Access ladder fall protection screen

SUPPLEMENTAL INSTRUCTION No. ***

Title: Access ladder fall protection screen

Title: Low canopy roof detail

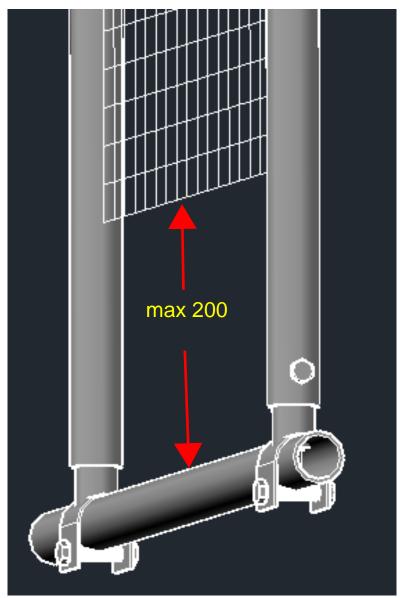
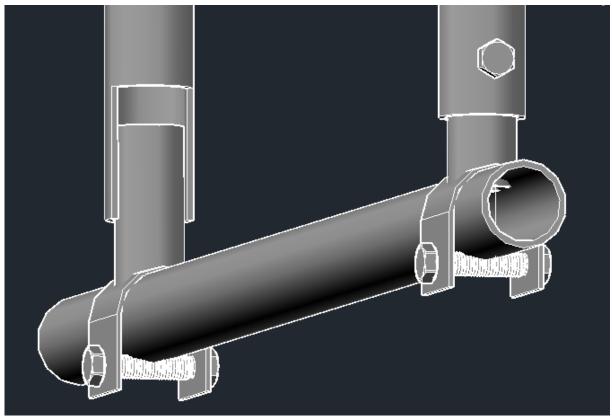
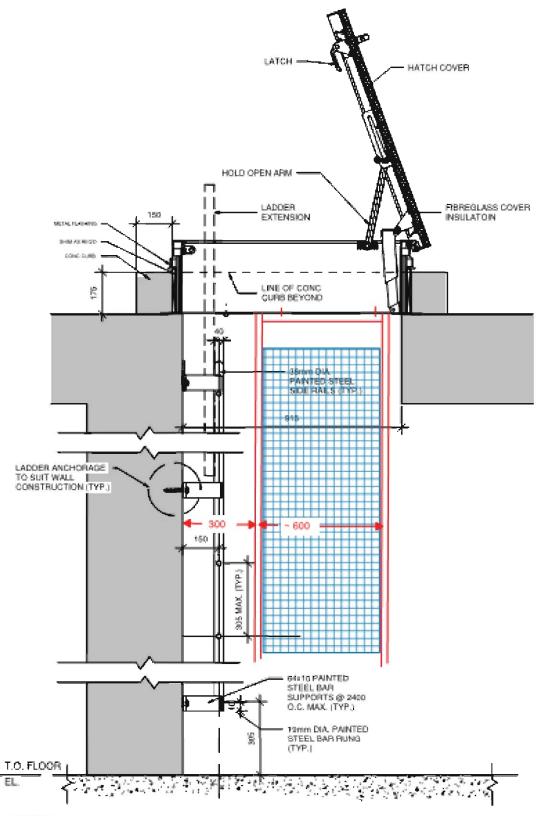
376 1. Add provide fall protection screen as shown on the attached architectural sketches. The vertical mesh screen and the attachments to be engineered.

Proposed attachment to guardrail detail NOTE: all attachment details to be engineered

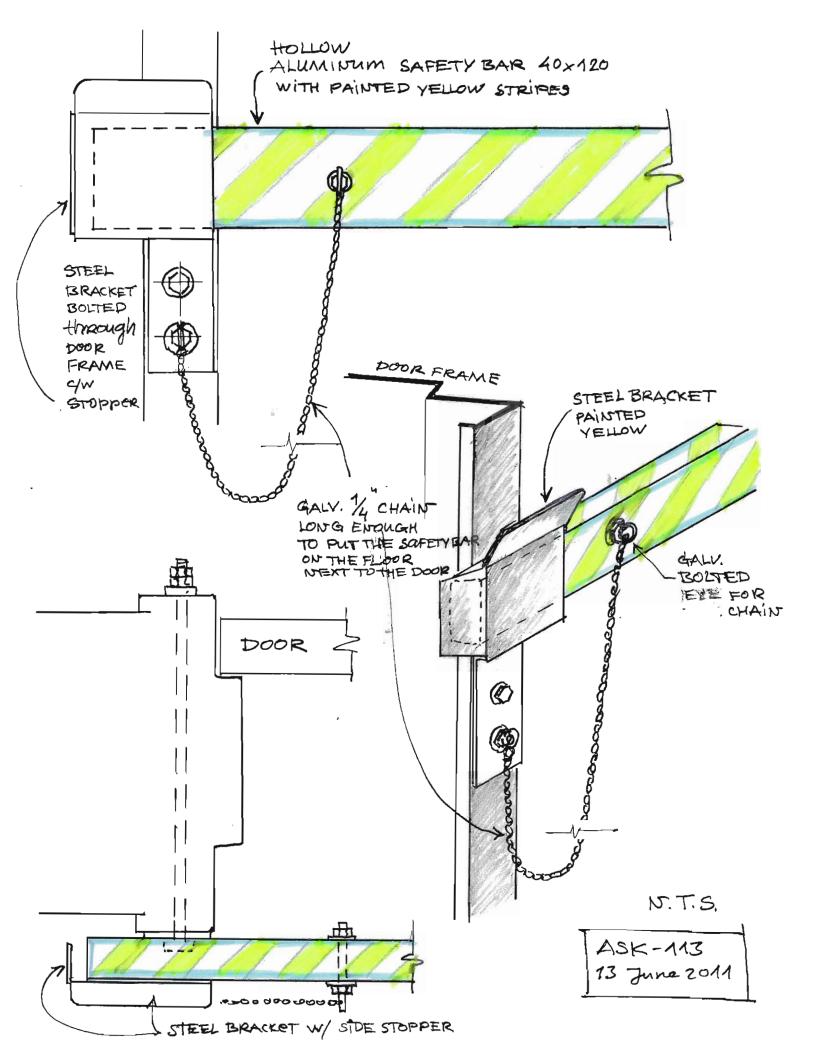
*** 1. Refer to attached sketch for clarification regarding non standard roof detail.

SAFETY TIE OFF TYPICAL DETAIL N.T.S. ASK-115 21 June 2011

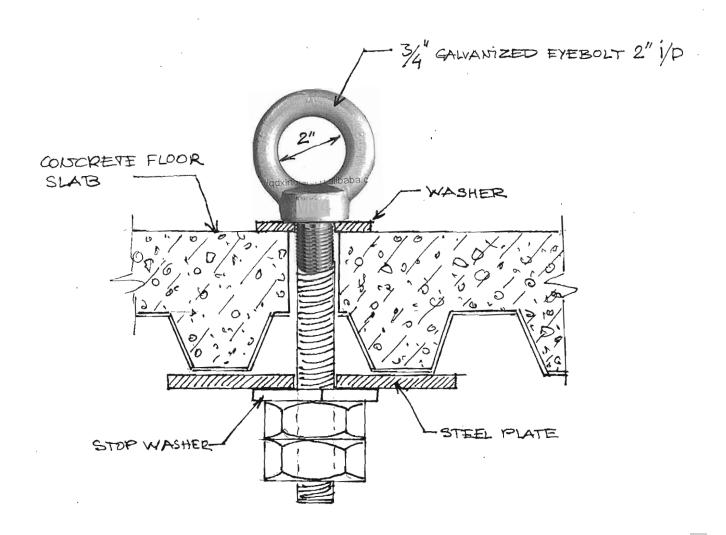
Additional double door to Mechanical room 3001 on 3rd floor with (custom) safety features as required (hand sketches by me) – the door is high above ground floor and it's needed for large equipment replacement and maintenance. This door was added because of some changes on the mechanical part during construction.
